Project	IEEE 802.16 Broadband Wireless Access Working Group < http://ieee802.org/16 >	
Title	Correction to Rx SNR, Rx sensitivity, and Tx Relative Constellation Error for OFDM and OFDMA systems.	
Date Submitted	2005-09-22	
Source(s)	Darcy Poulin [SiGe Semiconductor], Paul Pigginn [Cygnus Communications], Ran Yaniv [Alvarion], Dov Andelman [Intel]	Voice: [613-820-9244 x274] Fax: [Fax Number] [dp [at] sigecom.com] , ppigginn [at] cygnuscom.com
Re:	IEEE P80216_Cor1_D4	
Abstract	Correction to Rx SNR, Rx sensitivity, and Relative Constellation Error for OFDM and OFDMA systems.	
Purpose	The Rx SNR values in 802.16-2004 are incorrect. As a result, relative constellation error (EVM) and Rx sensitivity are also in error. In addition, there are many inconsistencies throughout section 8.3, 8.4, and 12.4 specifying EVM and Rx SNR. This submission attempts to resolve these inconsistencies.	
Notice	This document has been prepared to assist IEEE 802.16. It is offered as a basis for discussion and is not binding on the contributing individual(s) or organization(s). The material in this document is subject to change in form and content after further study. The contributor(s) reserve(s) the right to

Figure 1: Theoretical BER for OFDMA in AWGN

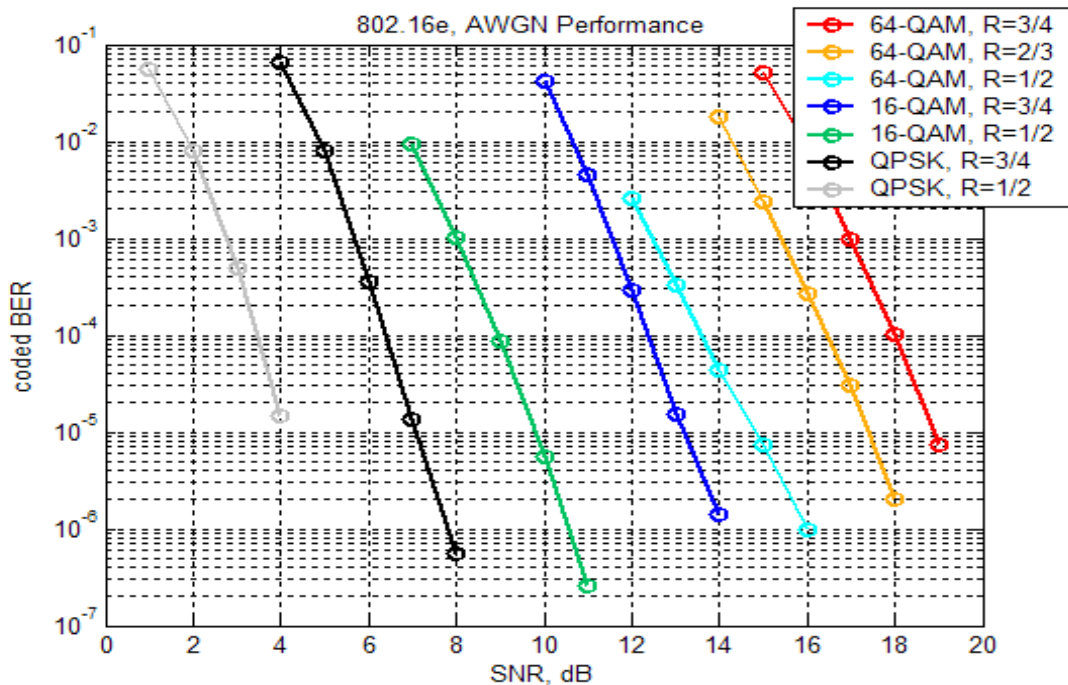
The Rx SNR in the 802.16-2004 standard for OFDMA is incorrect. The correct values for an ideal OFDMA receiver, in order to decode OFDMA with a BER of $1e-6$, can be derived from **Figure 1**.

The correct values of Rx SNR are approximately 4.4 dB lower than they are in Table 338 of the current 802.16-2004 standard.

Modulation	Eb/No (dB)	Coding rate	Receiver SNR (dB)
QPSK	10.5	1/2	9.4 <u>5</u>
		3/4	11.2 <u>8</u>
16QAM	14.5	1/2	16.4 <u>10.5</u>
		3/4	18.2 <u>14</u>
64QAM	19.0	<u>1/2</u>	<u>16</u>
		2/3	22.7 <u>18</u>
		3/4	24.4 <u>20</u>
